**REVISED**

REF: SUP25-0010  
DATE: April 10, 2025

| Request                  | - | Special Use Permit for stand-alone solar array                    |
| Location                 | - | 0 Dura Avenue   |

# SITE PLAN 1

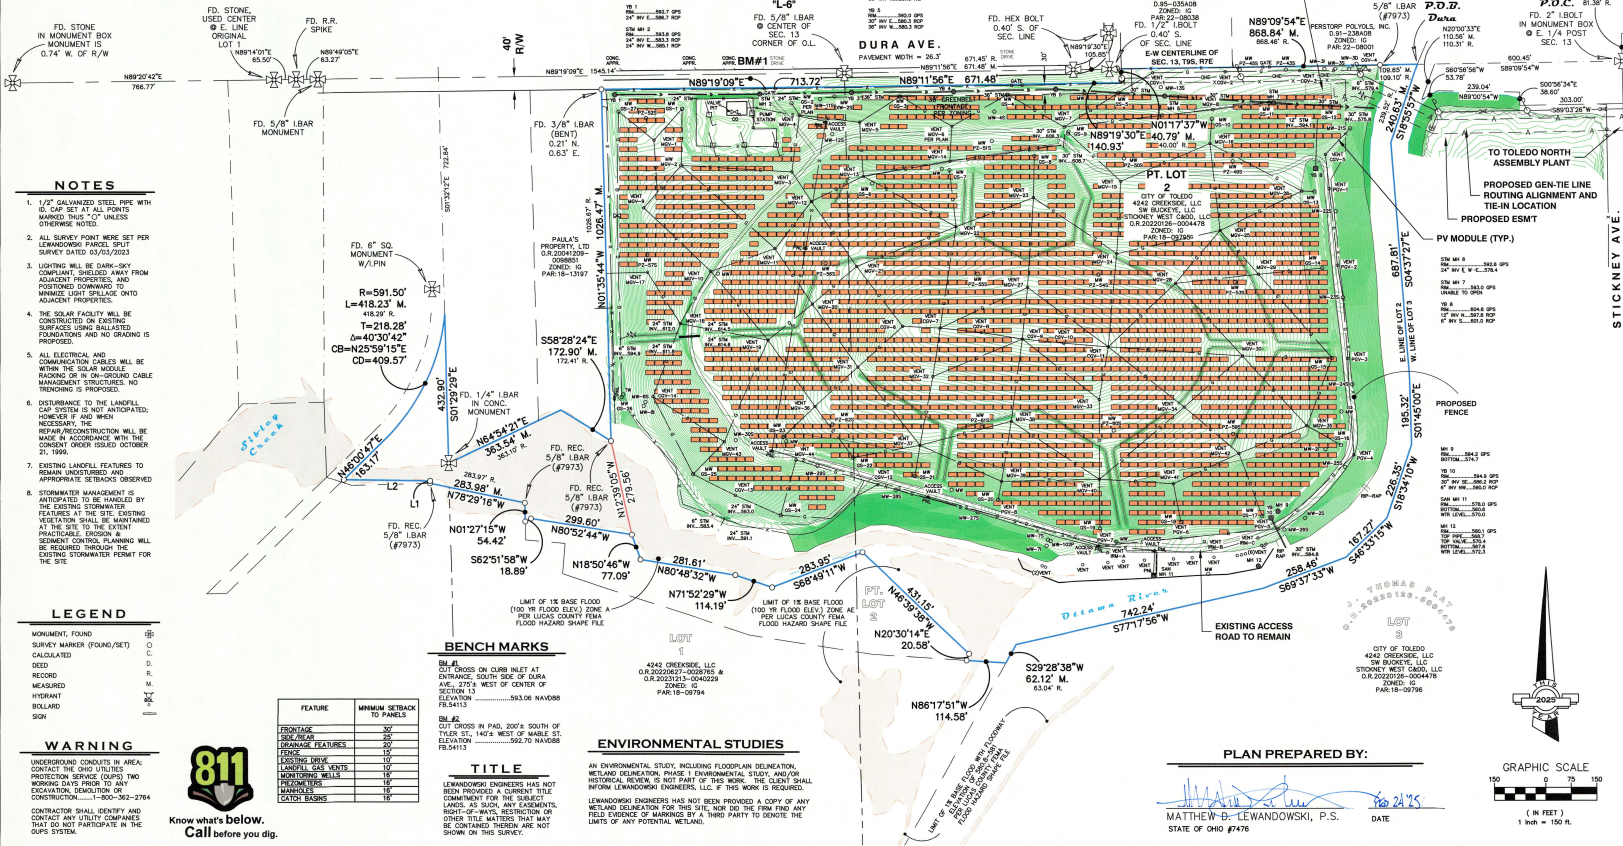
The site plan depicts access roads throughout the site. Per TMC§1107.1906 - Surfacing and Drainage, maneuvering areas, aisles and driveways must be surfaced with concrete, bituminous asphalt, or other dust-free material other than gravel or loose fill, and be graded to drain all surface water towards the interior of the parking lot. Since the site plan indicates that there will not be any disturbance to the landfill cap system, it is assumed that the access road will not be surfaced with concrete or asphalt. As such, the applicant will need to secure a waiver from this requirement.

Sites over five (5) acres are required to provide a thirty-foot (30') frontage greenbelt along the right-of-way per TMC§1108.0202 - Frontage Greenbelts. The frontage greenbelt shall include at least one (1) tree for every thirty-foot (30') of lot frontage. The submitted site plan depicts a thirty-foot (30') wide frontage greenbelt along Dura Avenue; however, a landscape plan has not been submitted that illustrates the required fifty (50) trees. Staff acknowledges that the site is intended for solar energy generation and trees can interfere with this. The applicant will need to secure a waiver from this requirement.

The site plan submitted depicts a seven-foot (7') Bekaert solidlock game fence, with wood posts and steel posts on the corners/ends, surrounding the solar arrays on all sides. This includes the area along Dura Avenue within the thirty-foot (30') front yard. ~~This material is acceptable on all sides with the exception of along Dura Avenue. The portion of the proposed fence along Dura Avenue shall be constructed of a material approved by the Plan Director as a condition of approval.~~ The Engineer for the project has noted that the Applicant is in fact not proposing this type of fence, but is instead proposing a seven-foot (7') high chain link fence with barbed wire as currently exists along Dura Avenue. ~~In addition~~ Per TMC§1105.0302(1), fences may not exceed 3½ feet in the front yard for all Industrial zoning districts. ~~In addition it appears that the fence will be electrified, and that a portion of the existing fence, which does not meet fence standards, will remain.~~ ~~In addition~~ per TMC§1105.0303, the use of barbed wire, razor wire, concertina wire, and electric fences are only permitted in Industrial districts and then only in the side and rear yards when not within 50 feet of a Residential district. Barbed wire, razor wire, concertina wire, and electric fences are also not permitted in the front yard or anywhere along a street right-of-way. The applicant shall secure a waiver to the applicable code sections to allow for the proposed fence height and type in the required front yard along Dura Avenue. ~~Additionally as a condition of approval, the site plan shall be revised to reflect the correct type of fence material proposed.~~

5. A SWP3 submittal is required; note 8 on each sheet of the proposed site plan is insufficient to meet the requirement, since a 513 permit for one of the landfills is the only document that calls out surface water management, and the requirements of the 513 are not known to be to the standards of the Ohio Construction General Permit. Toledo requires a SWP3 for projects over 2,500 square feet of construction activity. Placement of the fill (ballast) would constitute a construction activity. The total disturbance of the project would not just be the footprint of the ballasts however and would also include the remainder of the area that will be disturbed by construction activities, including construction traffic. If any of the site is to experience heavy construction traffic from equipment and will disturb the earth, that would need to be accounted for in the calculation of the total disturbed area. The entire project including the electrical transmission work offsite will need tallied, and if greater than an acre, an NOI will also be need to be submitted and authorized by OEPA.

7. Provide 60 ft wide clear space above the 36" storm and 42" sanitary sewers.

Approve a waiver so that the proposed access roads for the solar energy facility do not have to be surfaced with concrete, asphalt or other dust-free material. Staff is in support of the waiver as the access roads will have minimal use once the facility is constructed.

Approve a waiver to allow a mix of evergreen trees, large shrubs or other plant material, as approved by the Plan Director, in lieu of the fifty (50) trees required along Dura Avenue. Staff is in support of the waiver as large shade trees may interfere with the collection of solar energy on the site.

Approve a waiver to allow for a seven-foot (7') high fence in the front yard along Dura Avenue. Staff is in support of this waiver due to the nature of the proposed use and the need for site safety and security. Additionally, the adjacent property and the property along the north side of Dura Avenue is zoned and used for industrial purposes.

Approve a waiver to allow for ~~an electrified fence~~ a chain link fence with barbed wire in the front yard along Dura Avenue. Staff is in support of this waiver due to the nature of the proposed use and the need for site safety and security. Additionally, the adjacent property and the property along the north side of Dura Avenue is zoned and used for industrial purposes.
